Review of Plus-Point with Ceramic Wear-Face

Figure 1 Tube R2C69 of steam generator 24 scanned in 1997

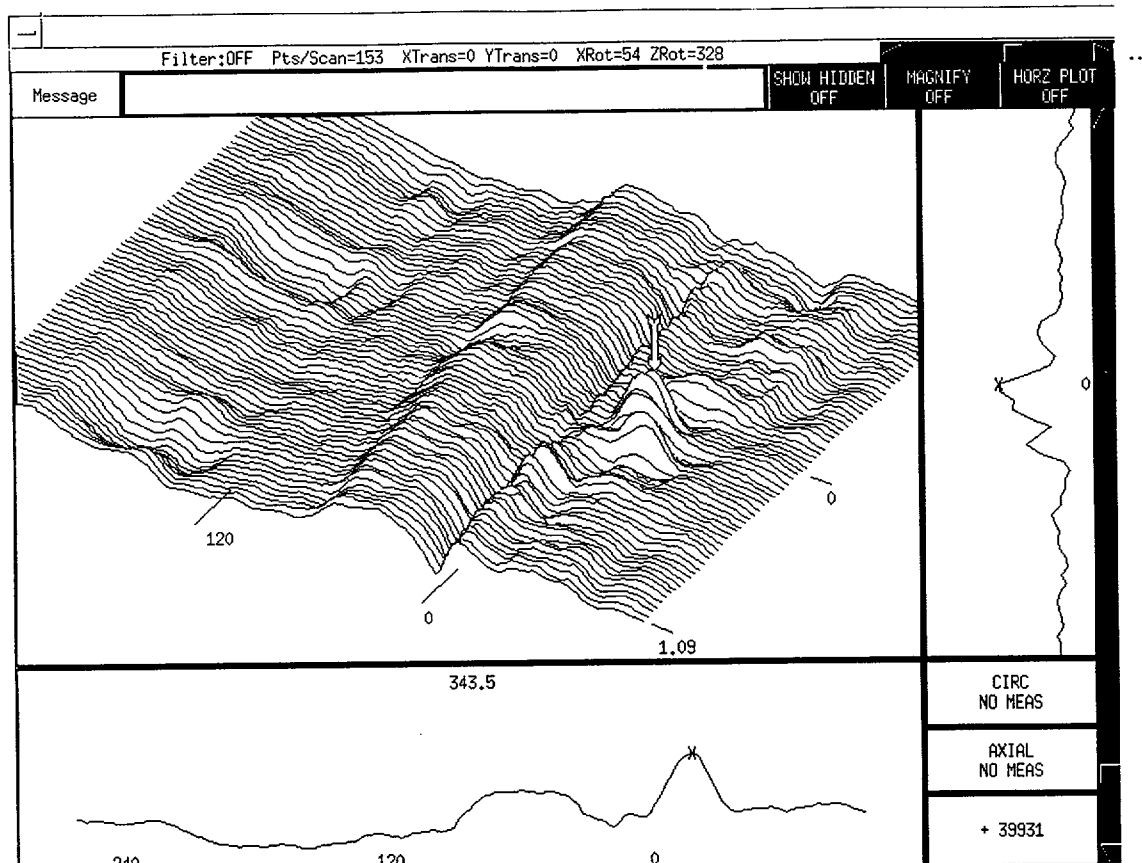
I have performed a quick check on the response of the probes on the standard in steam generator 22. Both probes give about the same response on both the od and the id notches. In Figure 1 we show the response of both probes to the od notches. These are the most important in the sludge pile region, since the defects found thus far are on the od. The notches are 60%, 40% and 20% deep. Note that while the 20% od notch is detectable, the profile is quite poor. An average of this notch depth will give better agreement with the actual notch depth. The voltage reading on this notch is about 0.1-volts. At this voltage level, a small amount of noise will have a large influence on the depth measurement, which is determined from the phase angle of the defect signal. This is the reading on the standard, and readings on the tube usually contain more noise. The depth readings on the 40% notch are much better. The voltage of this vector has an amplitude of about 0.35-volts, which is large enough to give a stable phase reading. The 60% deep notch gives a much larger voltage, and a more stable depth reading. In general, when the voltage is above about 0.3-volts, the depth reading seems to be fairly reliable. This voltage level for an accurate depth readings will probably hold for relatively clean sections of the tube in the

Figure 2 Tube R2C69 of steam generator 24 scanned in 2000

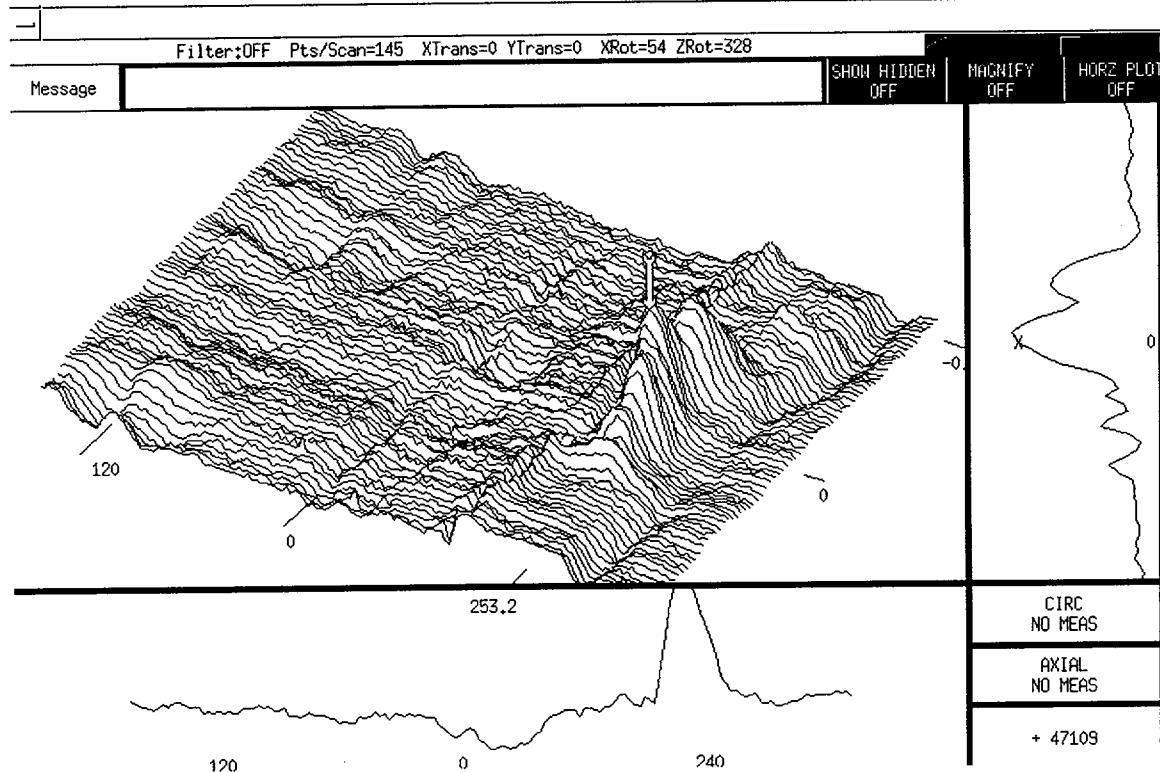
Here are scans of tube R2C69, both made with the mid-range probe at 400 kHz. It clearly appears larger in 2000. You already have scans made in 2000 with the high frequency plus-point, before and after the pressure test. Also, you have profiles of this tube made before and after the pressure test.
